Release Notes MLTG-CN

Version: 1.4.0-00123-7e047ba

Enhanced from version 1.3.2-00556-a549bc1

2. PtMP Support for Base Station Mode

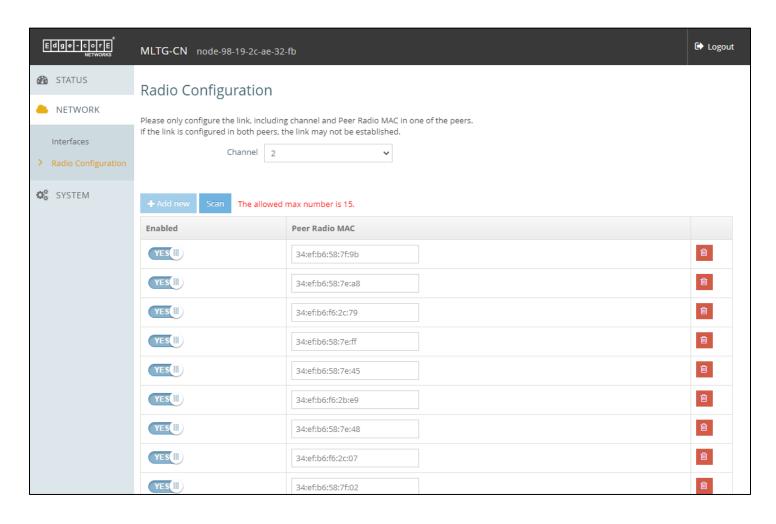
In Base Station mode, MLTG-CN supports setting up links to up to 15 Clients. On the other hand, due to the antenna characteristics, a Base Station mode MLTG-CN LR can only setup 1 link to a Client.

When a Base Station MLTG-CN connects with 15 Clients, the end-to-end total bi-directional throughput can reach 2Gbps (limited by Ethernet port speed).

4. 60GHz Radio Scan

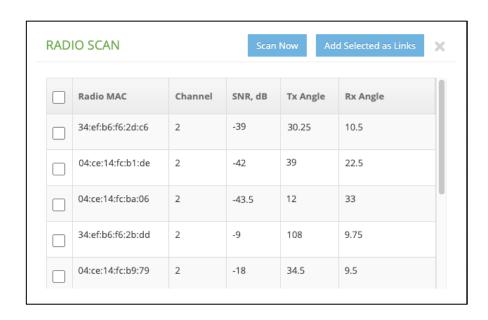
60GHz Radio Scan is supported for Base Station mode. The scan feature allows a Base Station to find out other MLTG-CN or MLTG-CN LR in the same channel. You can start the radio scan by clicking the "Scan" button in the Radio Configuration page.

The scan results will be listed as the screenshot above. The SNR and Tx/Rx angle for each radio scanned will be shown. The scan results can also be added as links directly.

5. Dashboard Enhancement

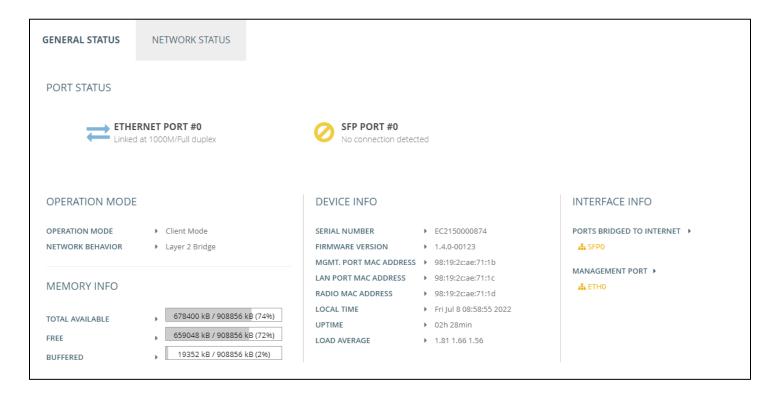
The Status Overview page is reformatted as a dashboard. The system information and status are shown with clearer layout. Port status and interface info are also added to the page.
